REPORT No. B-2017

Horns, Types H-1 and H-2

Schwarze Electric Co.

Report of Test

PLATE 3

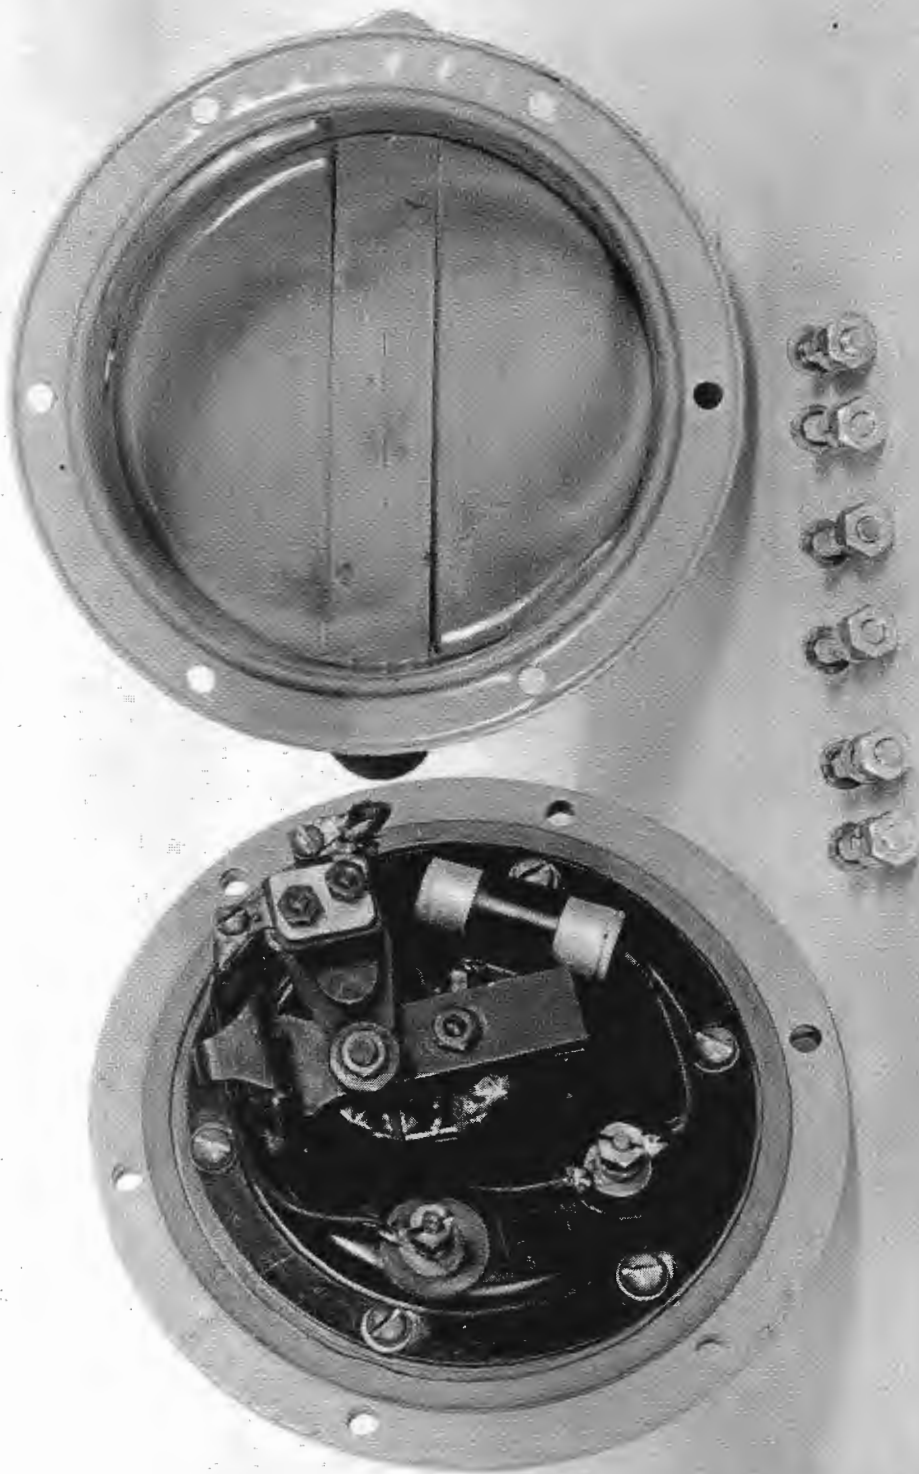
- (1) Endurance - The H-1 horn failed after 20 hours due to a fractured armature shaft, piece 56. The binding post insulator, pc. 37, was also found fractured.

- (4) Terminal blocks were not provided.
- (5) Terminal lugs were not provided.
- (6) One flat was provided in the side of each case in lieu of bosses.
- (7) The contact spring of the H-1 horn is of steel in lieu of phosphor bronze or beryllium copper.

- (8) The diaphragm of the H-1 horn is steel in lieu of nickel-chromium alloy.
- (9) The samples are designed for 2 point in lieu of 3 point mounting.
- (10) Drawings, references (d) and (e), do not agree with the samples submitted in regard to mounting straps, which, as furnished, penetrate the case. The material of the type H-2 diaphragm is given as steel, but was furnished as nickel chromium.

(a) That the type H-1 horn be considered NOT SATISFACTORY for Naval use in view of the deficiencies noted under "Conclusions".
